Service Bulletin 522

Issue 1 - February 2015

Subject: Secondary Air Injection Solenoid Retaining Bracket				
Bulletin Number	Models Affected	VIN Range		Markets Affected
522	Tiger Sport	From	655855	All except Brazil
		To	698242

1. Fixing
2. Secondary air injection solenoid retaining bracket
3. Airbox

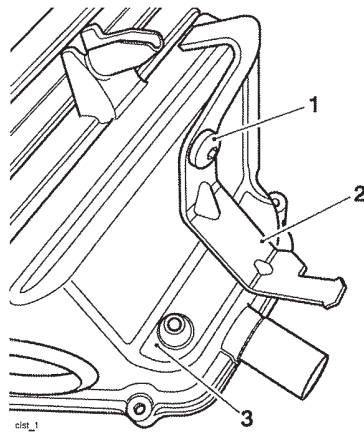
We have identified that the secondary air injection solenoid retaining bracket has not been fitted to Tiger Sport models in the VIN range above.

1. Remove the fuel tank as described in the Service Manual.
2. Remove the airbox as described in the Service Manual.
3. Install the secondary air injection solenoid retaining bracket to the airbox using the fixing. Tighten the fixing to **3 Nm**.

1. Secondary air injection solenoid valve
2. Secondary air injection solenoid retaining bracket
3. Hose

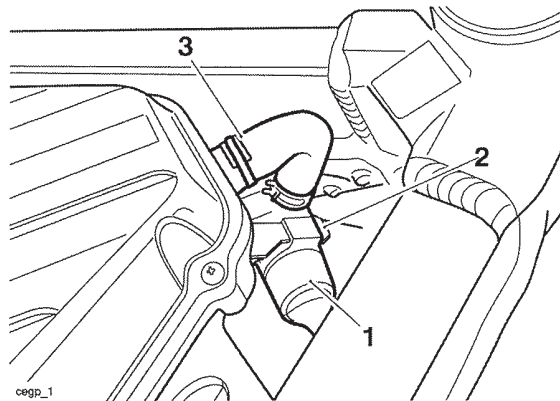
4. Check the orientation of the secondary air injection solenoid valve prior to fitting to retaining bracket. If necessary, disconnect the secondary air injection solenoid valve from hoses, and rotate 180° to align with retaining bracket. Re-install hoses.
5. Install the airbox as described in the Service Manual. Ensure secondary air injection solenoid valve is connected to the retaining bracket.
